Access Compliance Report

Public Rights-of-Way

| Intersection ID: 47278 | Main Street: BERNADINE_CT | Cross Street: CARRINGTON_FOREST_LN | Location: SW |
| ADA ID: B961CF9AC8AA | Ramp Type: Perp | Initial Pass/Fail: Fail | Overall Compliance: No |

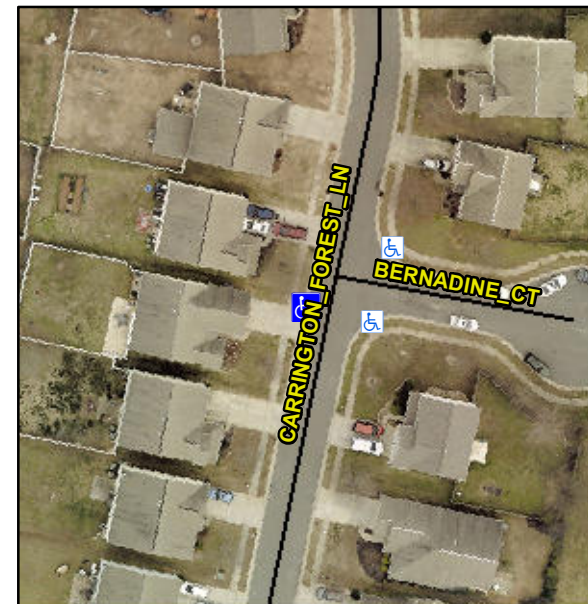
Not Found, R304.5.1, R304.5.3

| Compliance | Description | Data | Compliance | Description | Data |
|------------|-----------------------|-------|------------|-----------------------------|------|
| No | Ramp Width (in) | 35.0 | No | Ramp XSlope (%) | 3.9 |

Remove & Replace Entire Ramp.
